**TITLE: AIR CONDITIONING - CONDITIONED SERVICE AIR SYSTEM (CSAS) -
INSTALLATION OF IMPROVED CSAS CONTROL UNIT (CCU)**

MODIFICATION No.: 151673K15121

SERVICE BULLETIN No.: A320-21-1196

REVISION No.: 01 - Jan 27/11

Figure A-GBAAA - Sheet 01
Replace the CSAS Control Unit

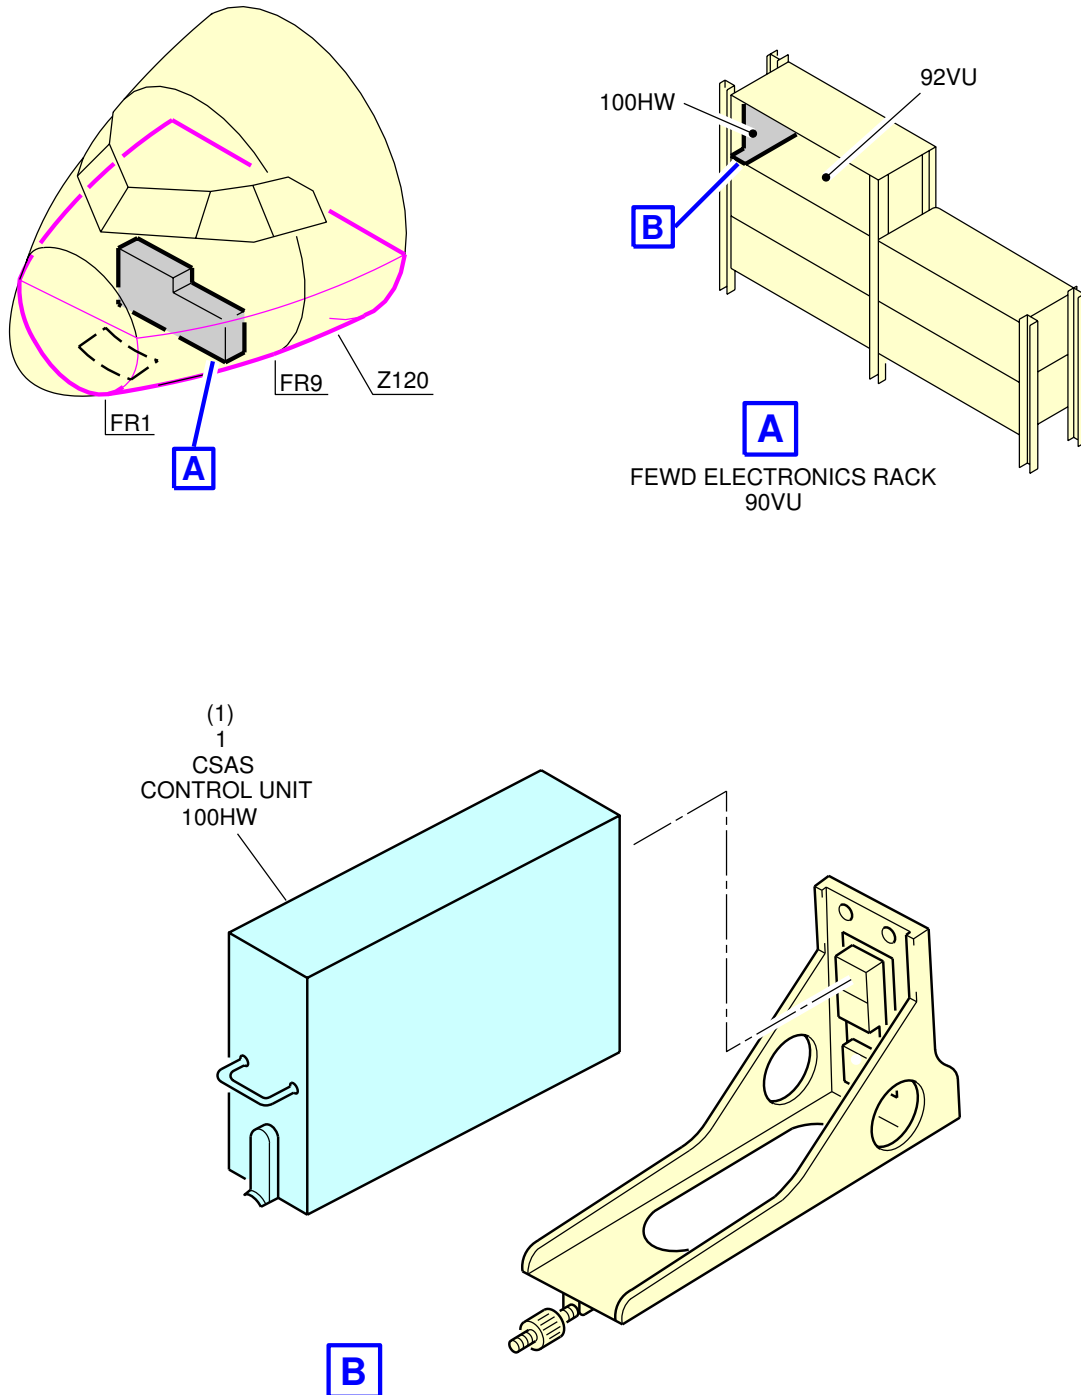
- (a) Remove (Refer to AMM Task 21-58-34-000-001) and [Fig. A-GBAAA Sheet 01](#):

1 Controller-CSAS 3959A0000K03 Item (1)

- (c) Install (Refer to AMM Task 21-58-34-400-001) and [Fig. A-GBAAA Sheet 01](#):

1 Controller-CSAS 3959A0000K04 Item 1
